# COVER SHEET

Mark-up Legend	
Building Review	
Engineering Review	
Fire Review	
Planning Review	
Public Works Review	
Traffic Review	
APPROVED	
BY	CITY OF PUYALLUP DEVELOPMENT ENGINEERING
DATE	
NOTE: THIS APPROVAL IS VOID AFTER 180 DAYS FROM APPROVAL DATE. THE CITY WILL NOT BE RESPONSIBLE FOR ERRORS AND/OR OMISSIONS ON THESE PLANS. FIELD CONDITIONS MAY DICTATE CHANGES TO THESE PLANS AS DETERMINED BY THE DEVELOPMENT ENGINEERING MANAGER.

FOR  
**ARCO ampm PUYALLUP**  
SEC. 33, TWN. 20 N, RGE. 4 E, W.M.  
CITY OF PUYALLUP, PIERCE COUNTY

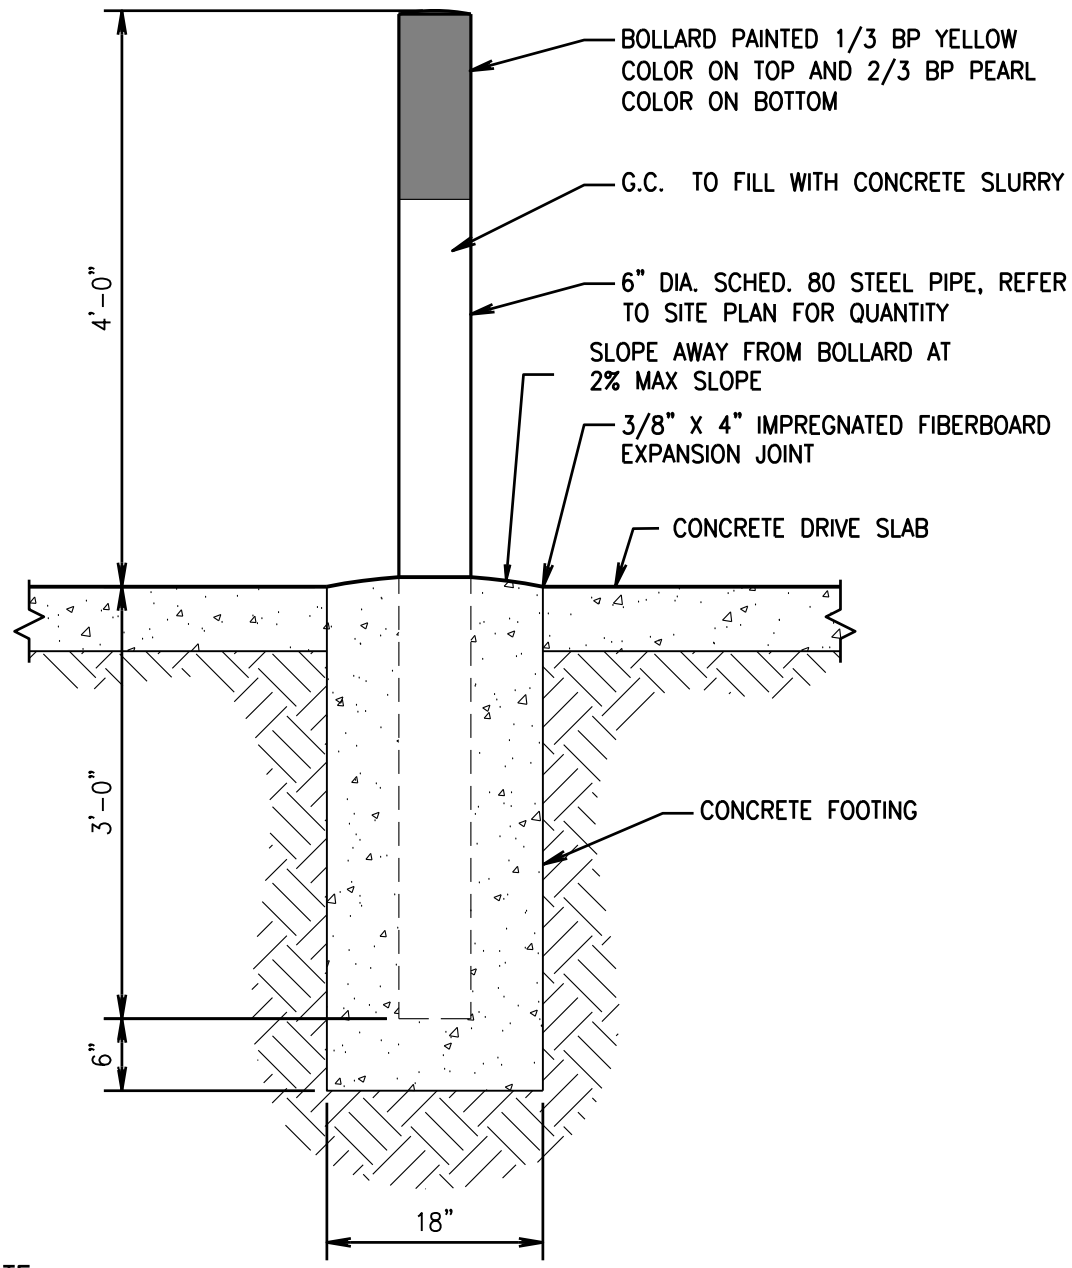
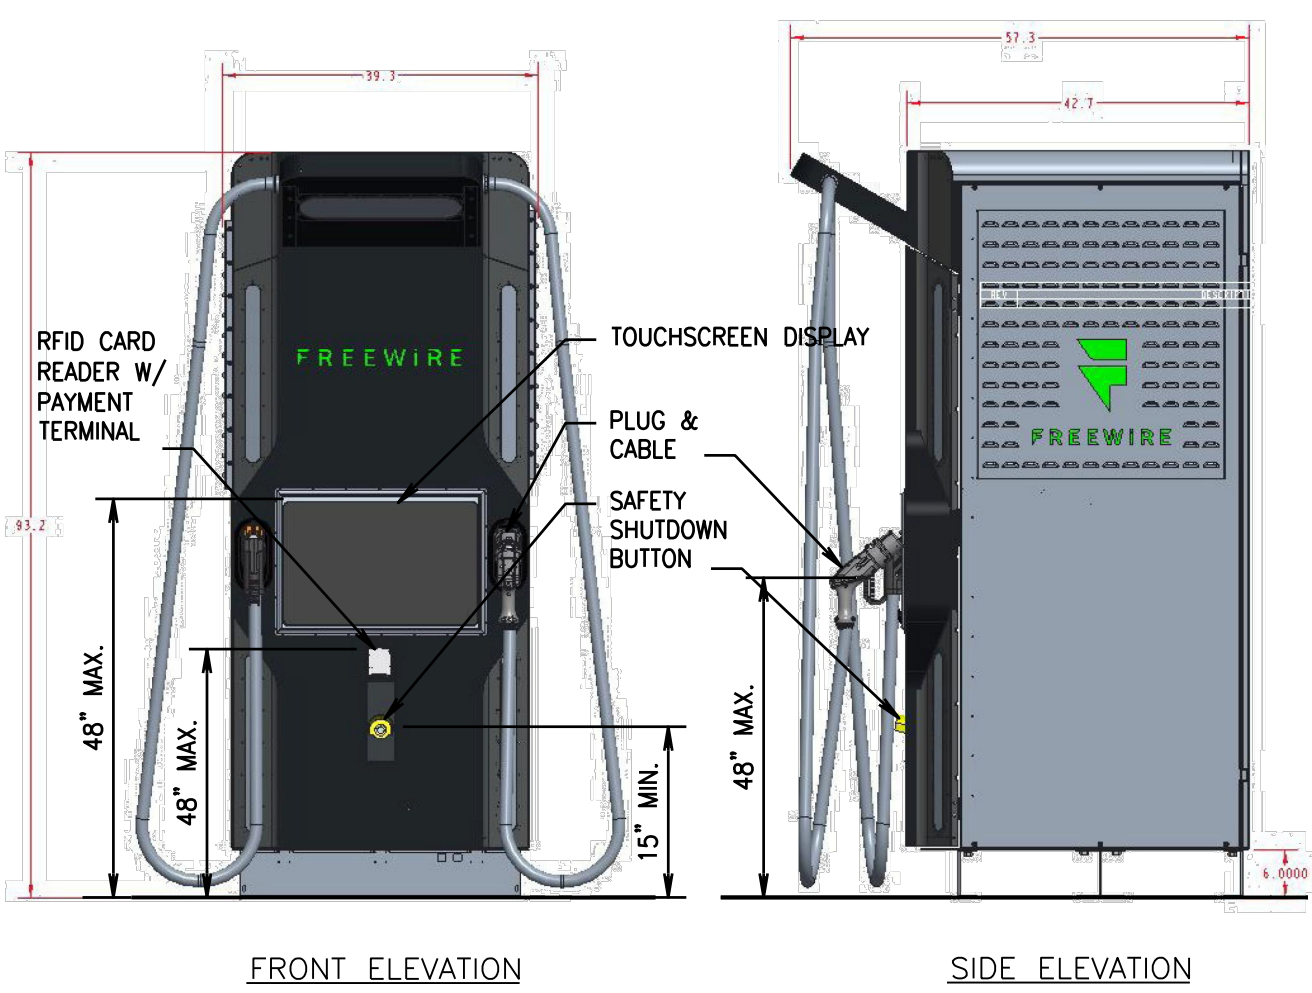
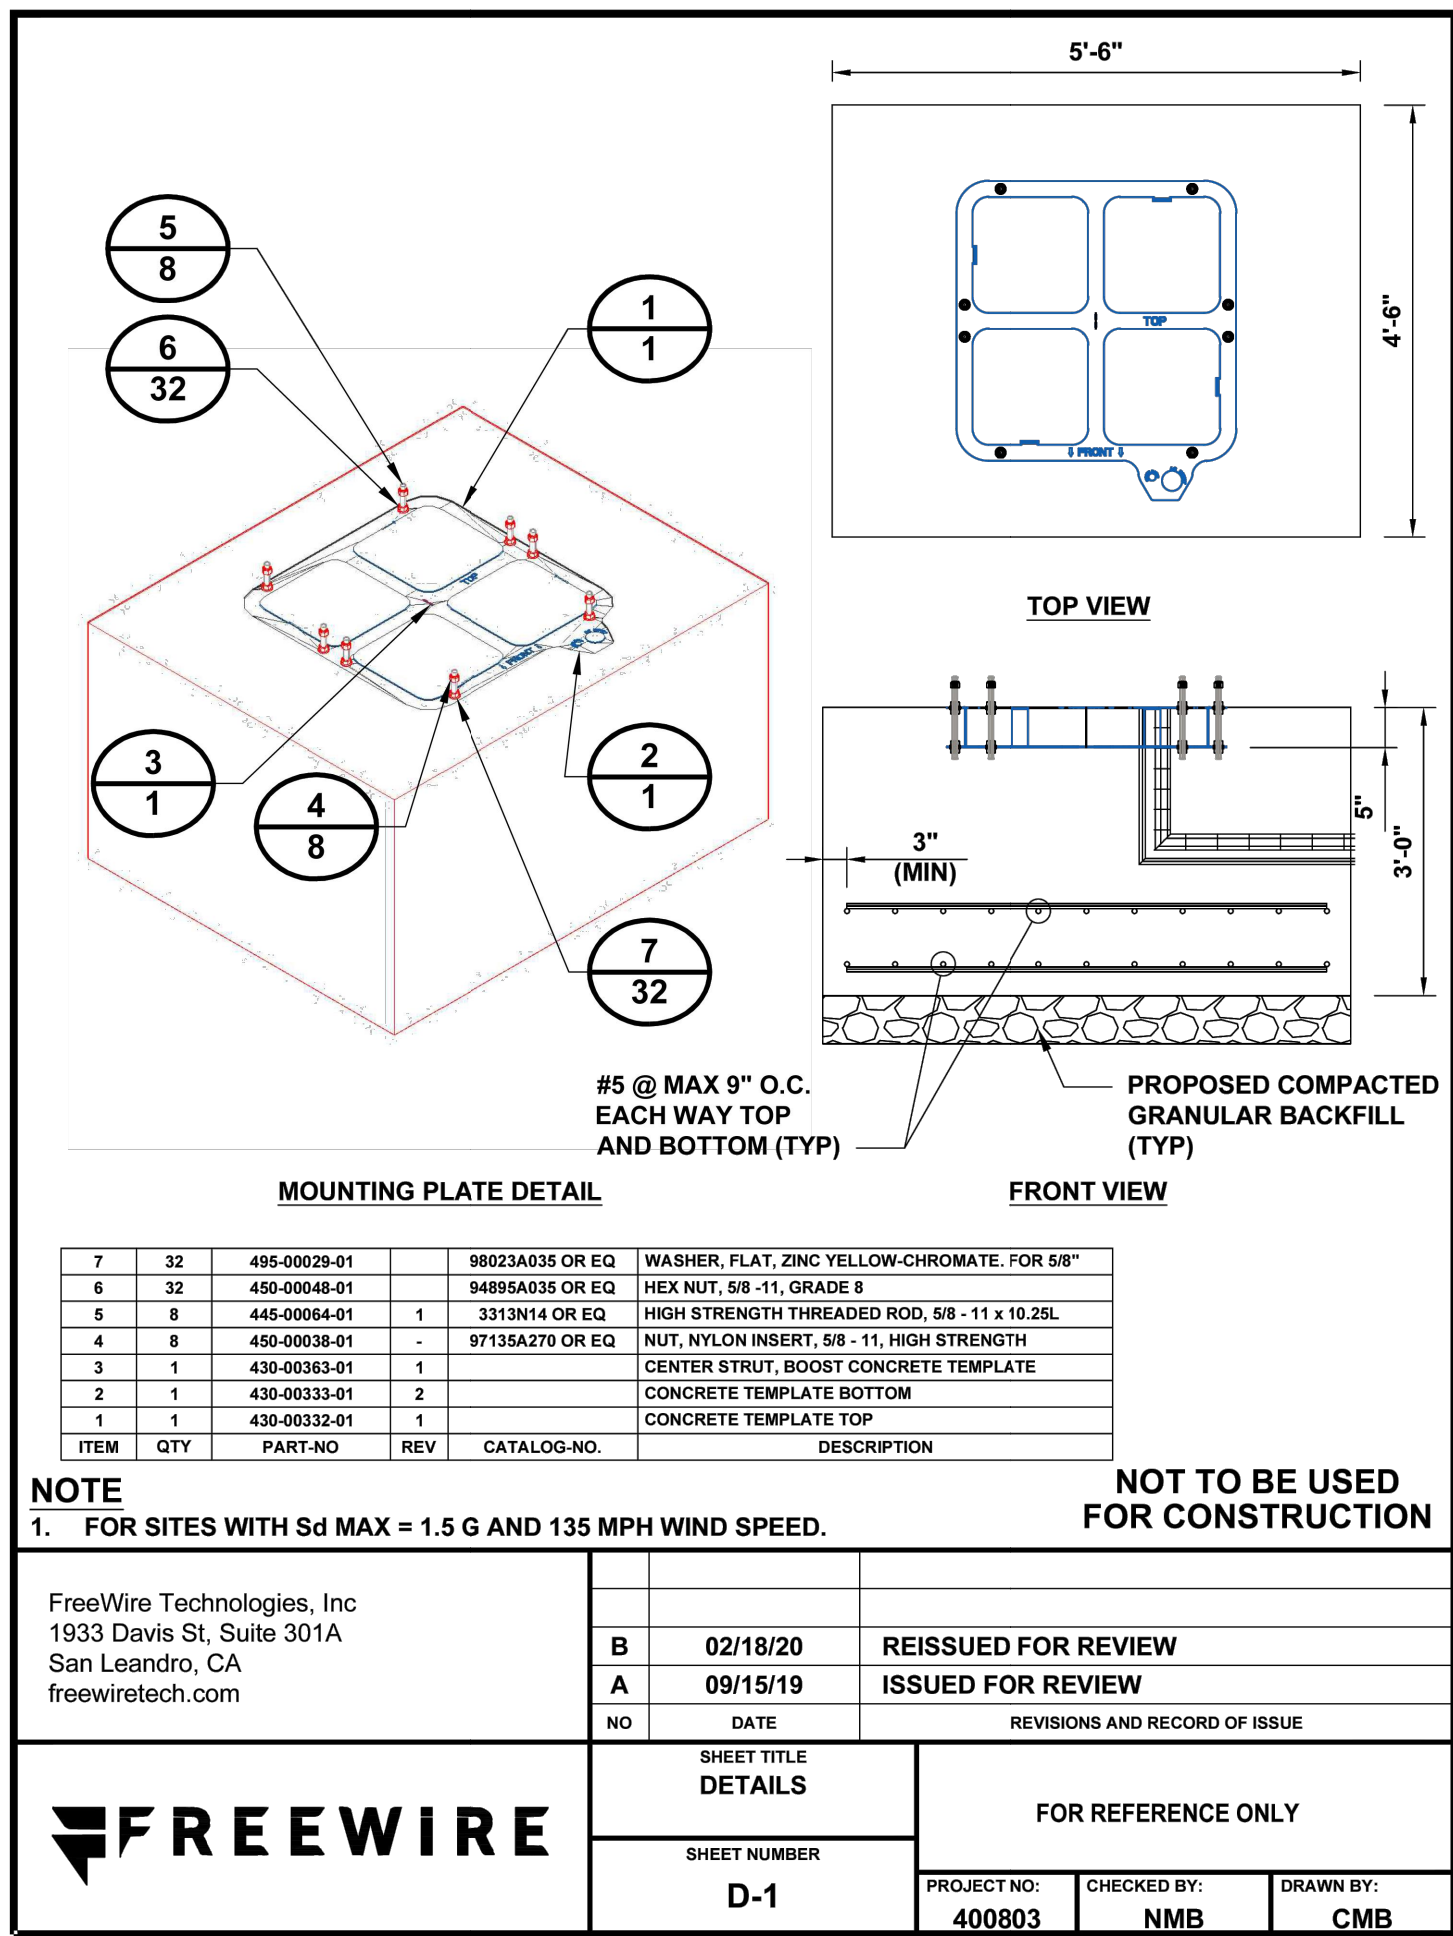
There are several building permits that have been submitted. Provide a specific reference to the plans in question or provide the overall depth of the base. [civils, sheet C7.2]

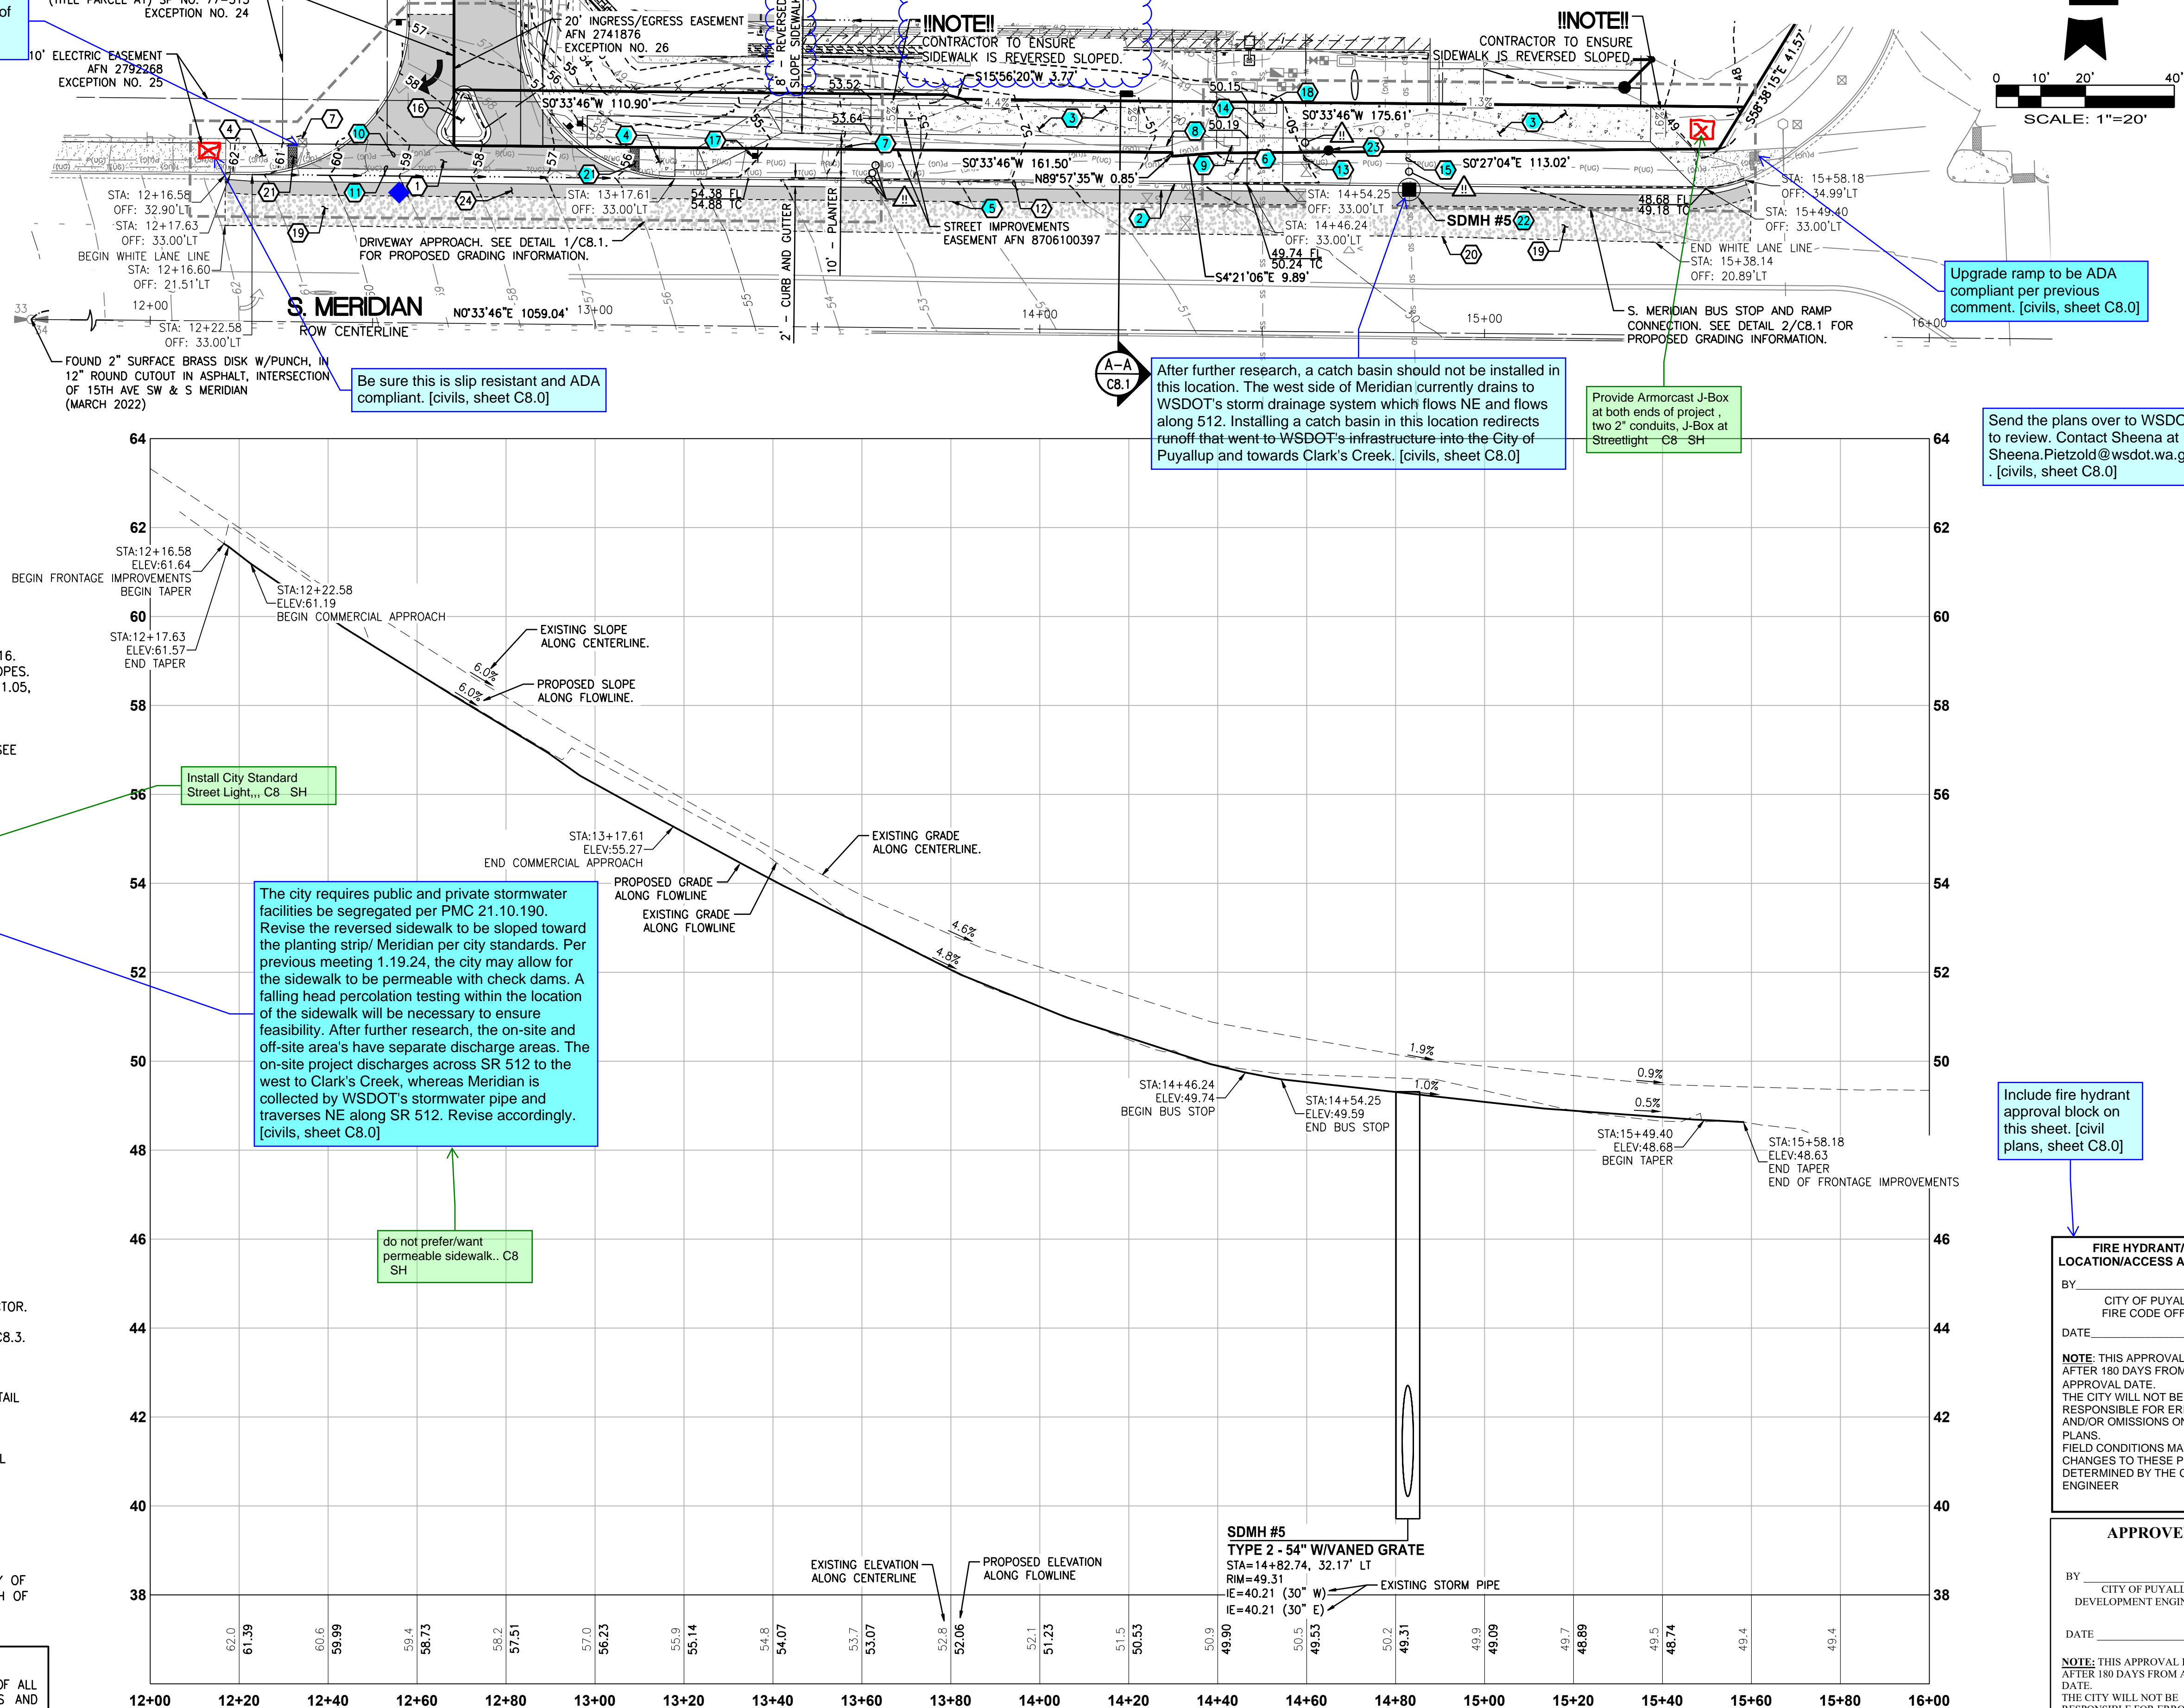
Show WSDOT stormwater  
infrastructure. [civils, sheet C8.0]

Upgrade ramp to be ADA  
compliant per previous  
comment. [civils, sheet C8.0]

After further research, a catch basin should not be installed in this location. The west side of Meridian currently drains to WSDOT's storm drainage system which flows NE and flows along 512. Installing a catch basin in this location redirects runoff that went to WSDOT's infrastructure into the City of Puyallup and towards Clark's Creek. [civils, sheet C8.0]

Provide Armorcast J-Box  
at both ends of project,  
two 2" conduits, J-Box at  
Streetlight - C8 - SH

Send the plans over to WSDOT  
to review. Contact Sheena at  
Sheena.Pietzold@wsdot.wa.gov  
[civils, sheet C8.0]

**1 S MERIDIAN DRIVEWAY DETAIL**  
SCALE: 1" = 5'

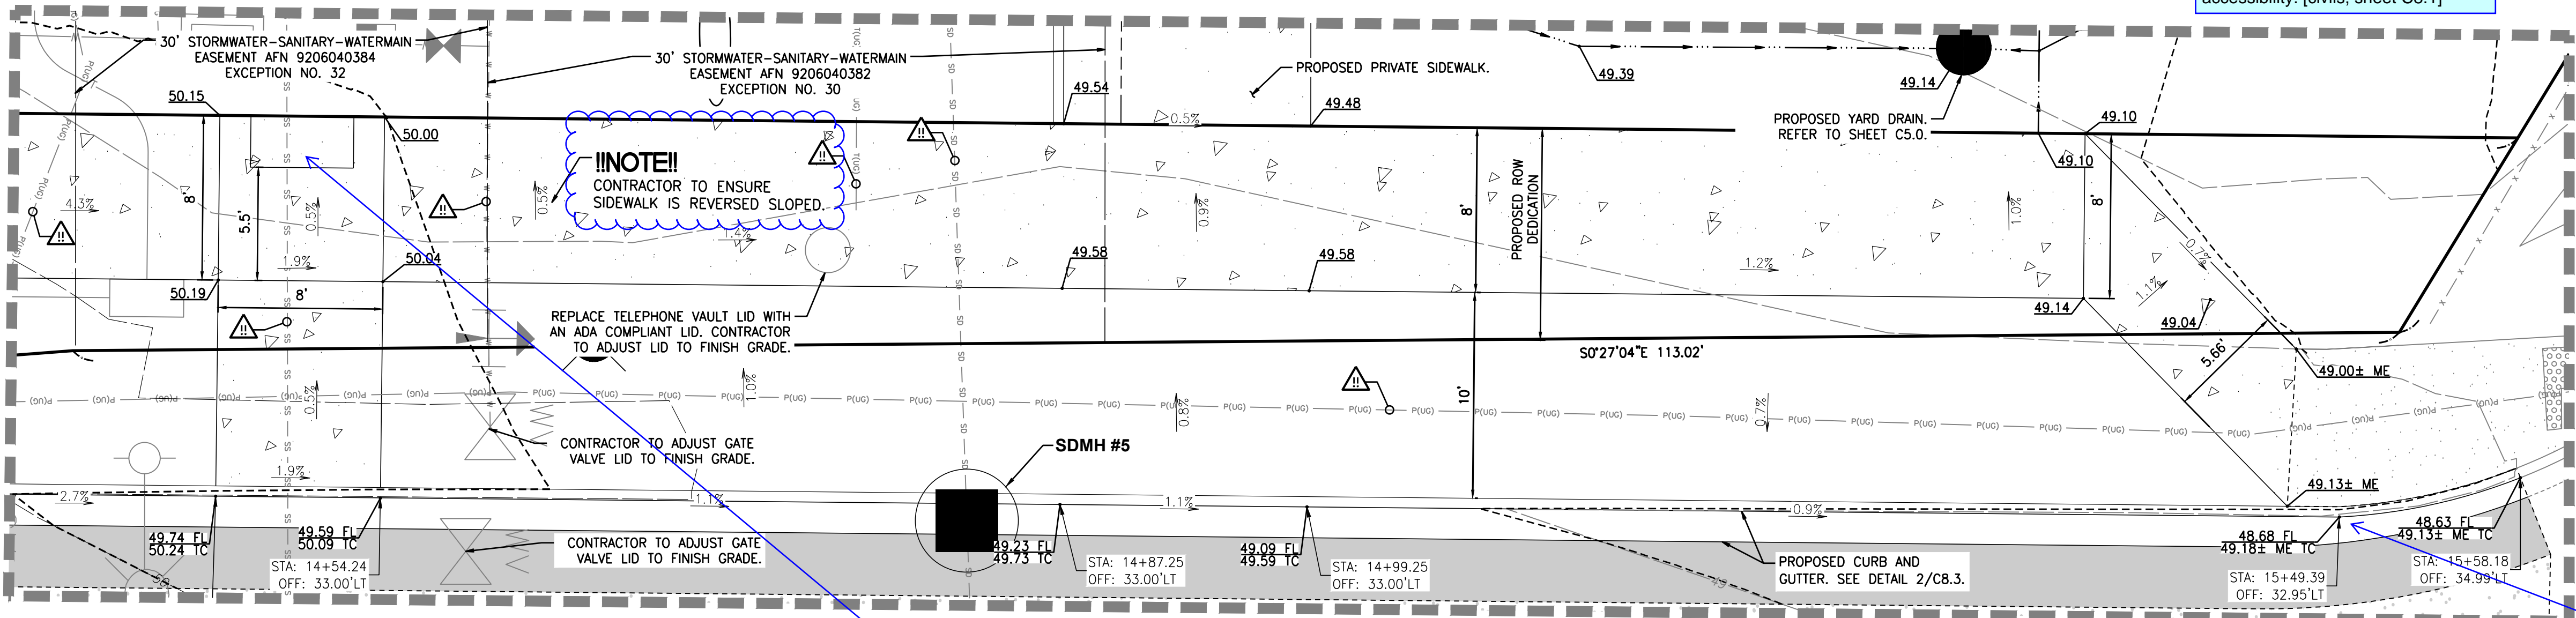
Relocate the bus stop bench outside of the 30' utility easement. The bench is proposed directly over top of the sewer main which will be upgraded as a city Capitol Improvement project in the near future [civils, sheet C8.1]
